ACCESSION NBR:8004080367 DOC.DATE: 80/04/01 NOTARIZED: NO DOCKET #
 FACIL:50-316 Donald C. Cook Nuclear Power Plant, Unit 2, Indiana & 05000316
 AUTH.NAME AUTHOR AFFILIATION
 MALONEY,G.P. Indiana & Michigan Electric Co.
 RECIP.NAME RECIPIENT AFFILIATION
 DENTON,H.R. Office of Nuclear Reactor Regulation

SUBJECT: Forwards addl info requested by NRC 790109 ltr, re analyses
 of containment temp response to postulated main steam line
 breaks.

Donald C. Cook Nuclear Plant Unit No. 2
Docket No. 50-316
License No. DPR-74
Subject: Request for Additional Information 022.17

Request for Additional Information

Figure Q22.17-1: Upper Compartment Temperature
(30% Power Level)

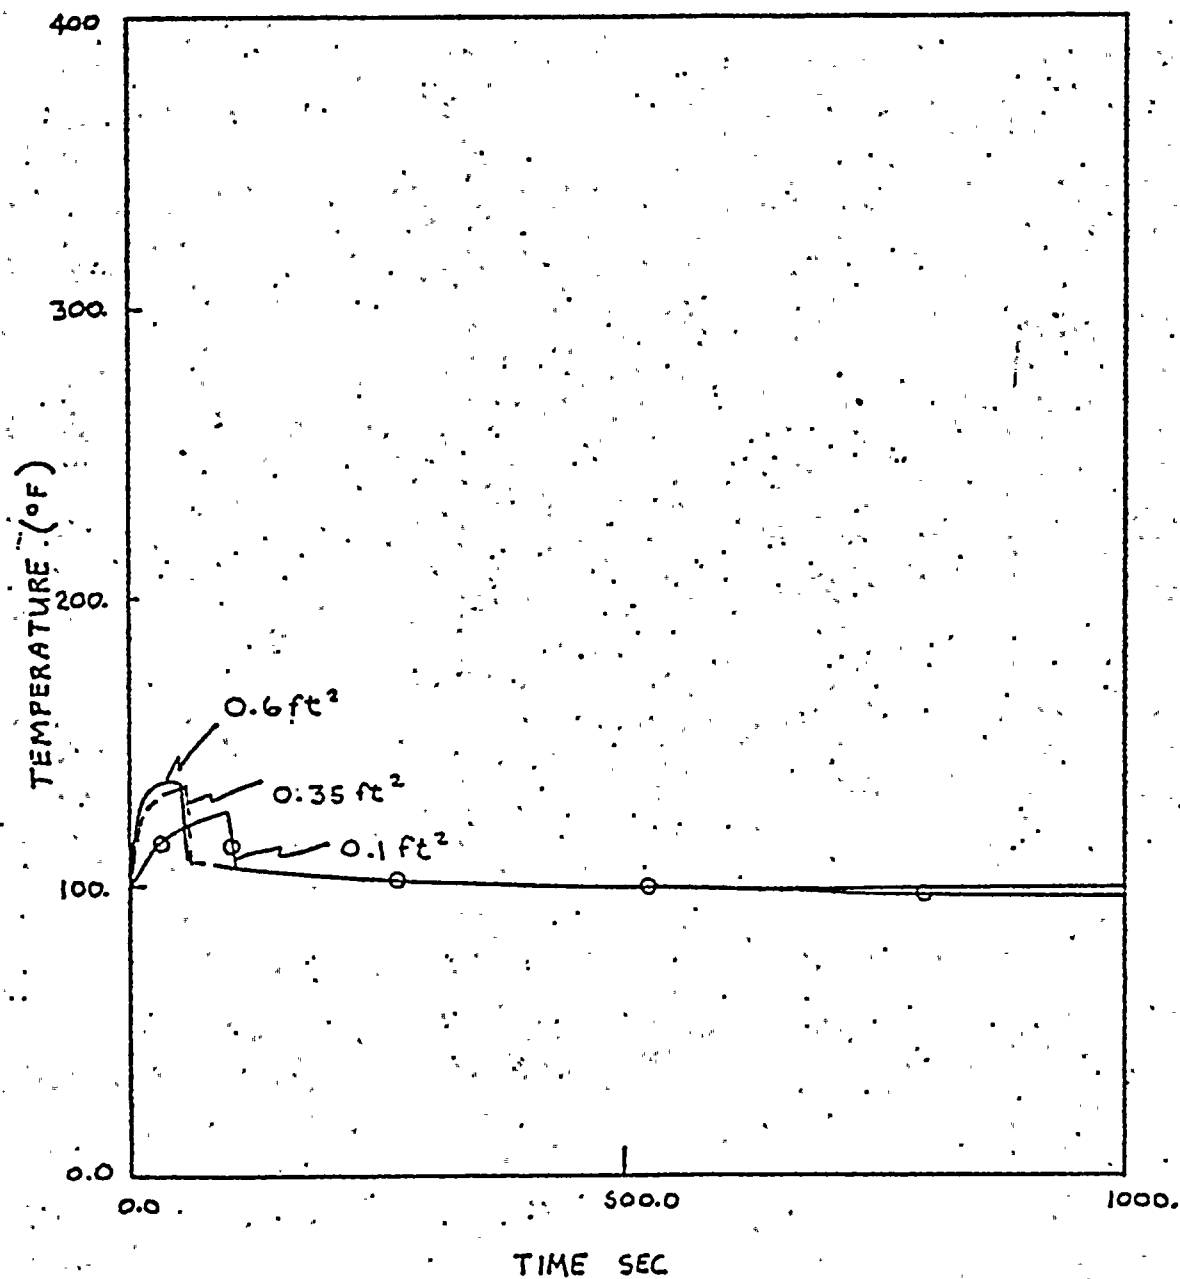
For each break analyzed provide: 1) a figure similar to figure 022.9-2 (Appendix Q) showing upper and lower compartment temperature as a function of time; 2) a figure showing containment pressure as a function of time; 3) a table similar to Table 022.9-2 (Appendix Q) identifying the mass and energy release rate data used in the containment analyses; and 4) identification of any actions assumed to be performed by a control room operator during the course of the accident and the time at which operator actions are assumed to occur including justification for the assumed operator actions.

This spectrum included breaks of 0.6, 0.35 and 0.10 ft². Attached Figures Q22.17-1 and Q22.17-2 provide the upper compartment temperature and lower compartment pressure transients. As Figure Q22.17-3 shows, similar lower compartment temperature transients were calculated for the spectrum of breaks analyzed. However, the 0.6 ft² break resulted in a slightly higher maximum lower compartment temperature. (See attached Table Q22.17-1). When this transient was compared to the transient identified as the most severe small break at 30% power in the previous analysis, it was found to result in very similar peaks, with the difference being incidental to the results. (See Figure Q22-17.4).
